Preservation Department – Item 3, LPC-25-09502

**361 Central Park West, aka 1-5 West 96th Street – First Church
of Christ, Scientist, of New York City – Individual Landmark
Borough of Manhattan**

Terrace Guardrail Update

March 19, 2025
Post Approval Amendment

Terrace Guardrail Current Proposed Design: Mesh 6'-0" South Elevation

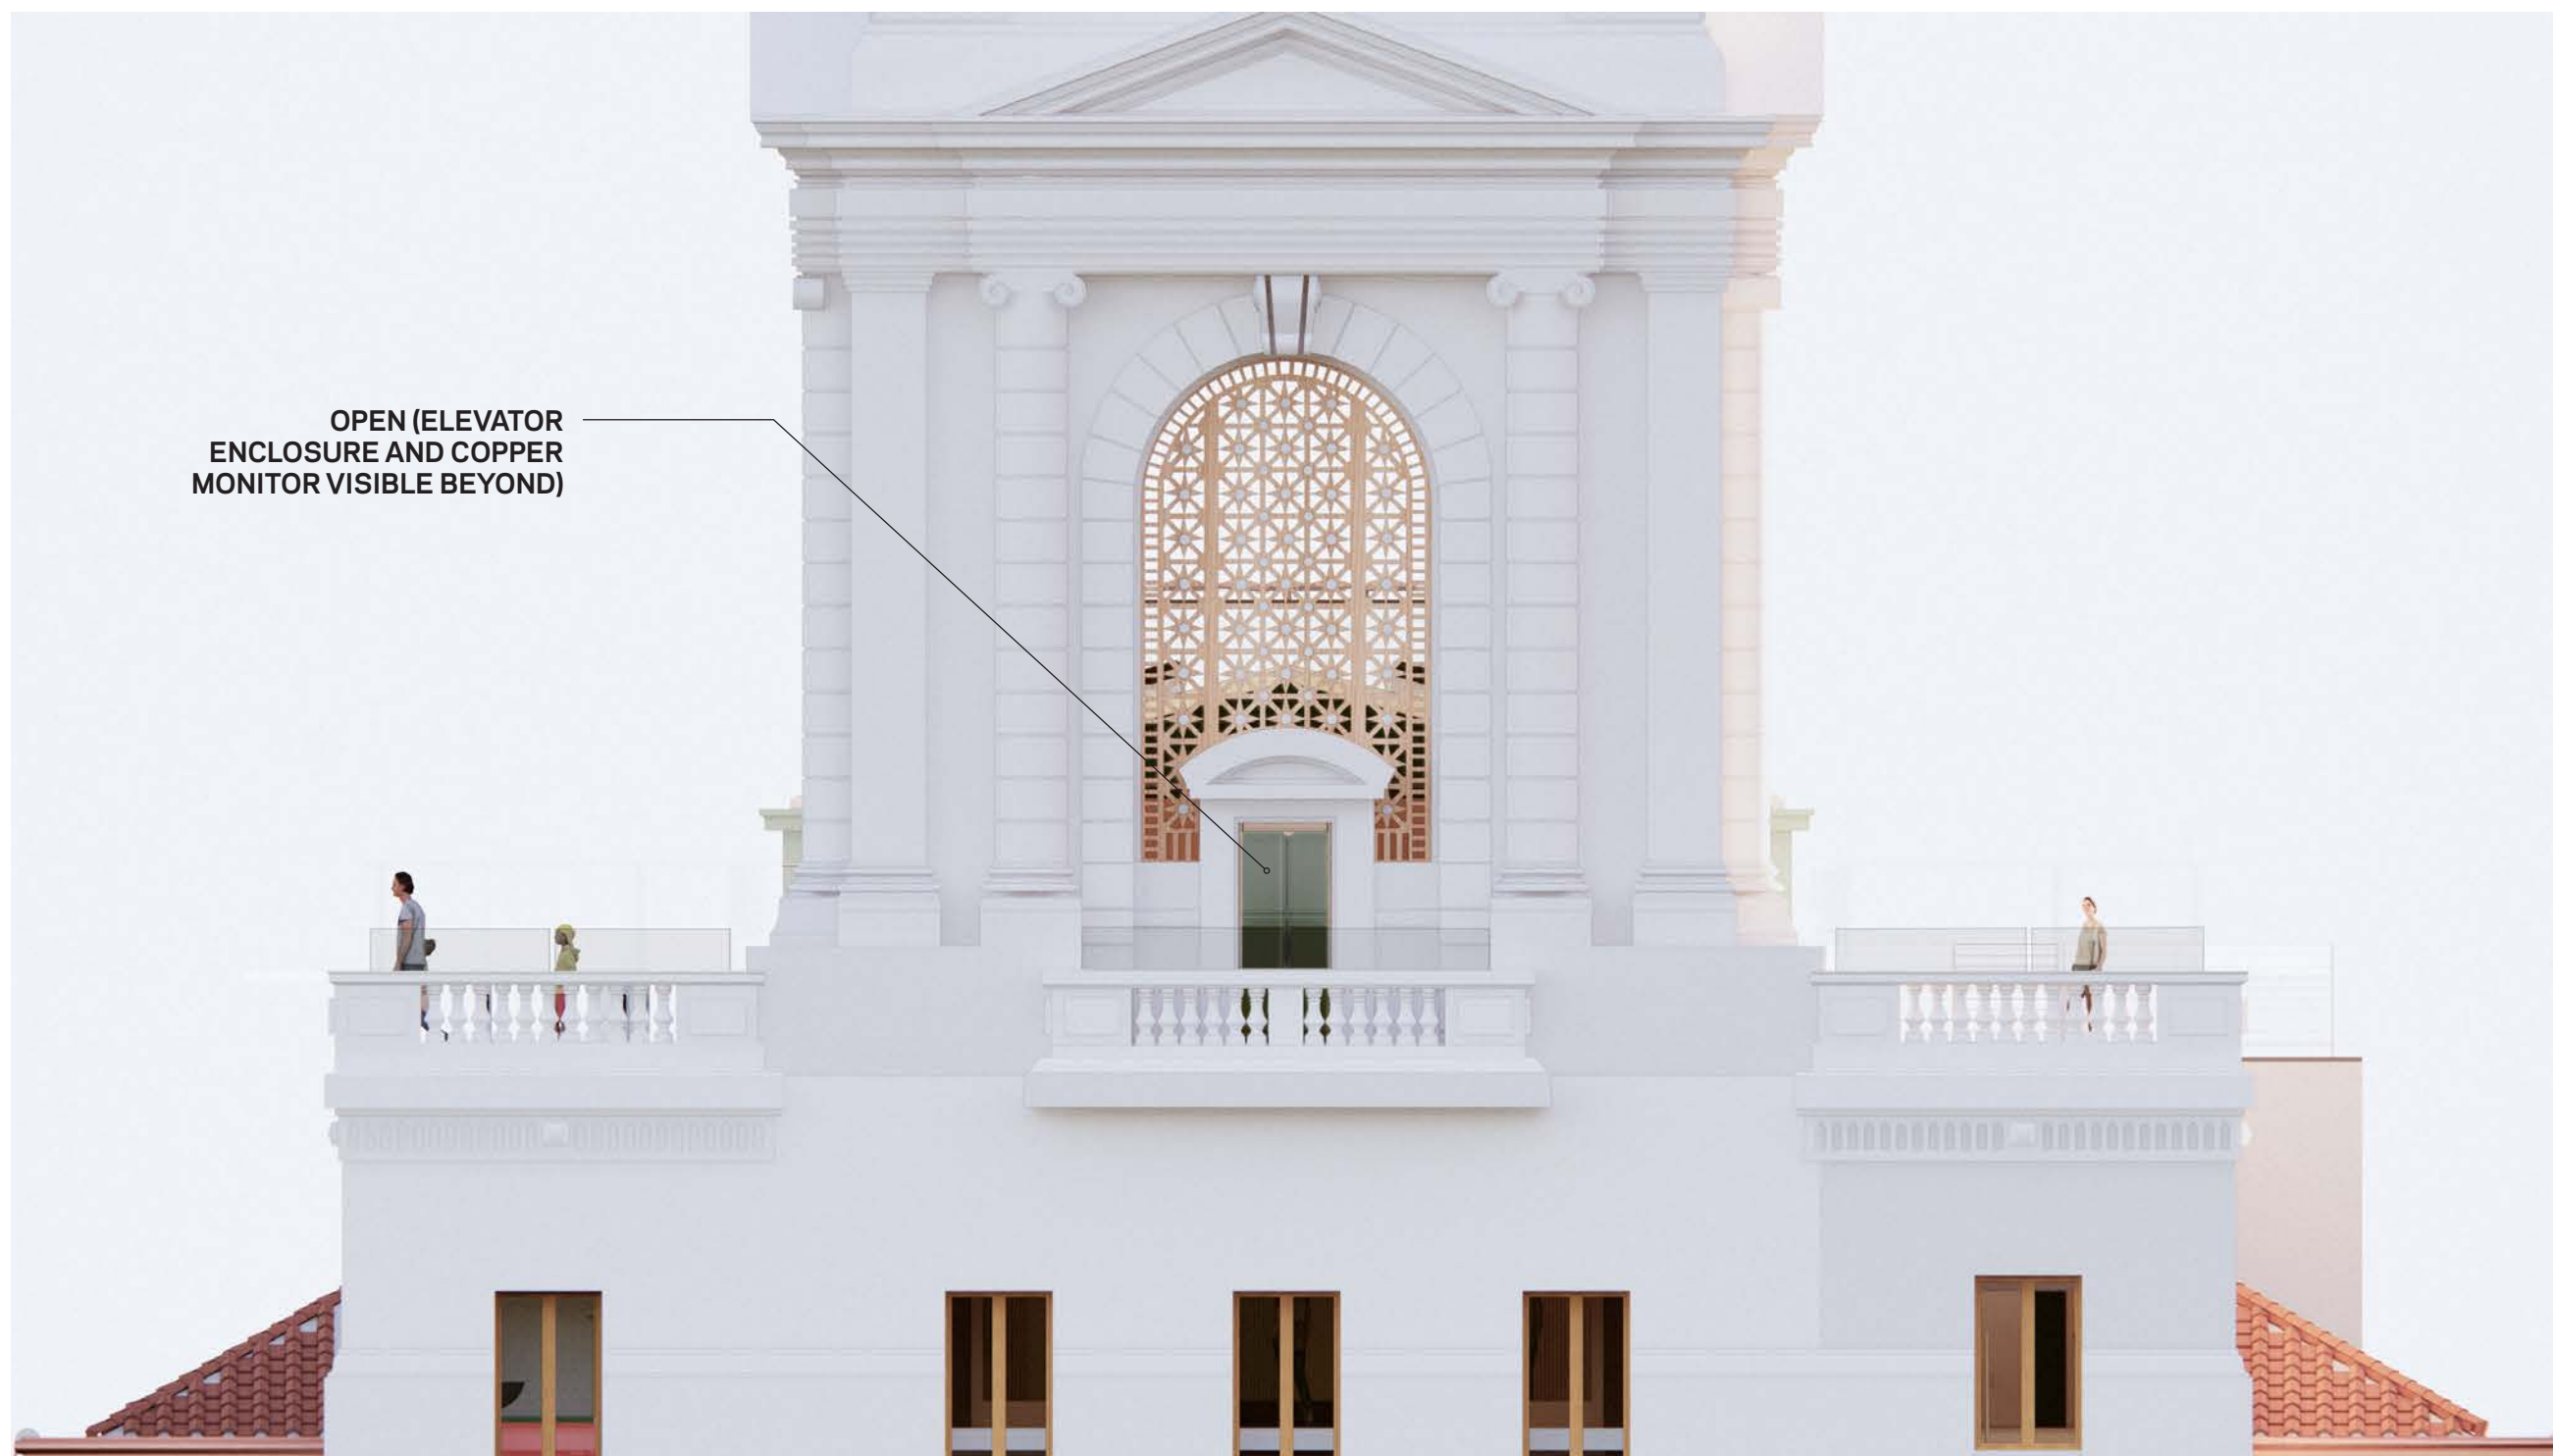
NO BOLLARD/
LIGHT AT END
POST
